**KETCHIKAN AIRPORT SHUTTLE
FERRY TRANSFER
BRIDGE REHABILITATION**

KETCHIKAN AIRPORT SHUTTLE FERRY TRANSFER BRIDGE REHABILITATION

KETCHIKAN AIRPORT SHUTTLE FERRY TRANSFER BRIDGE REHABILITATION
STRUCTURAL WELDING REHABILITATION CHANGES
STATE OF ALASKA
DEPARTMENT of TRANSPORTATION and PUBLIC FACILITIES
JUNEAU, ALASKA

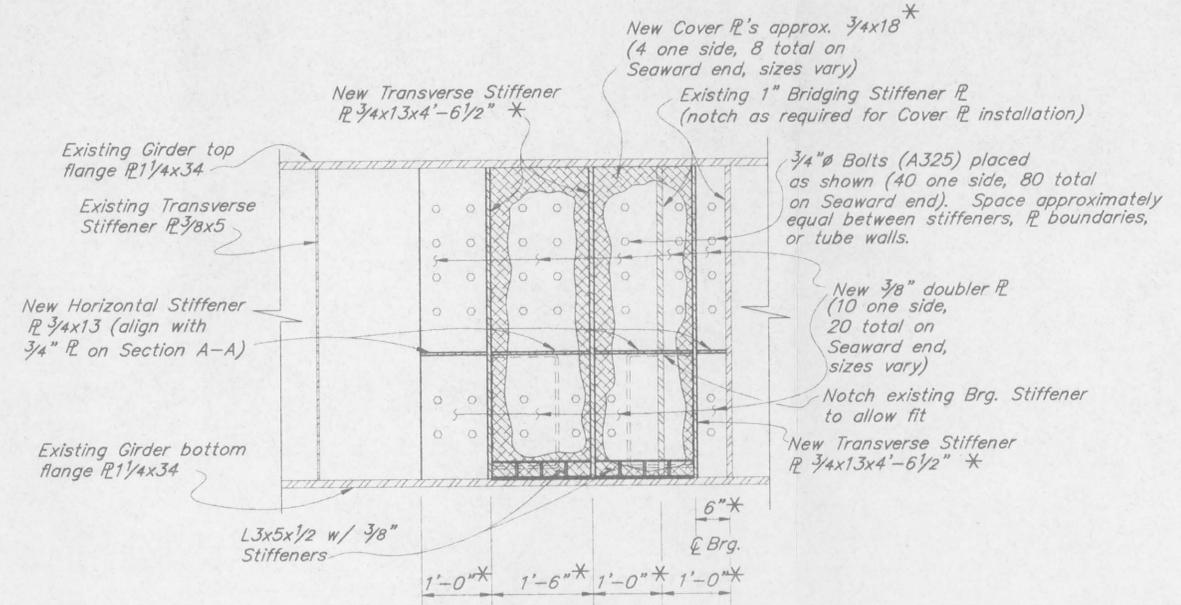
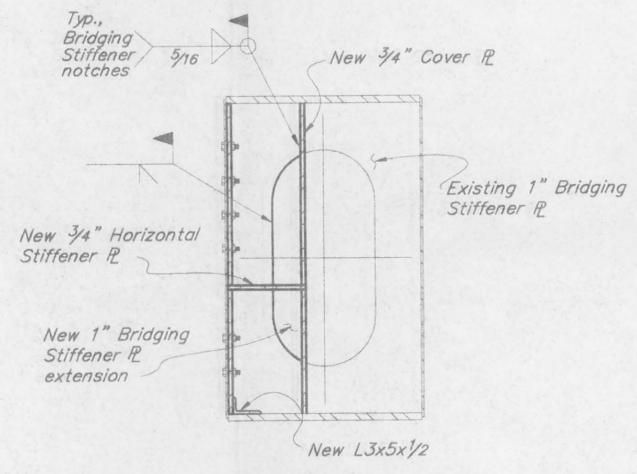
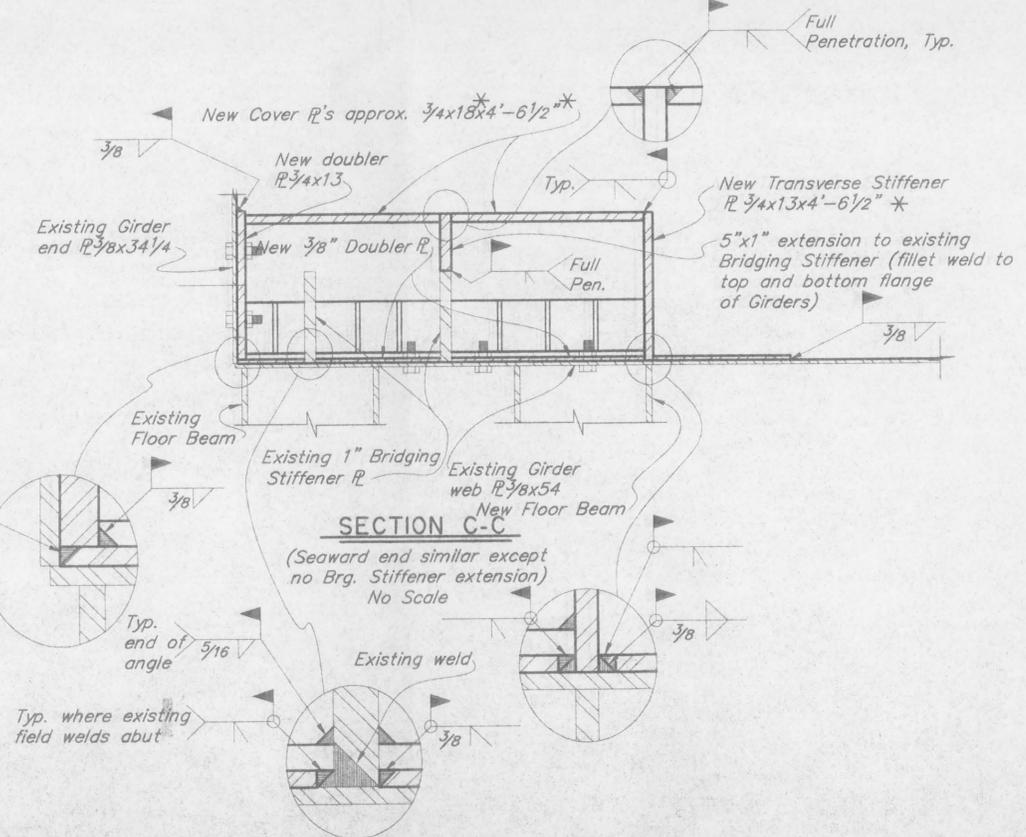
Notes:
These details replace corresponding details on Dwg. No. B-2. Other notes and details remain unchanged.
Nip corners of stiffeners as required to avoid existing welds.
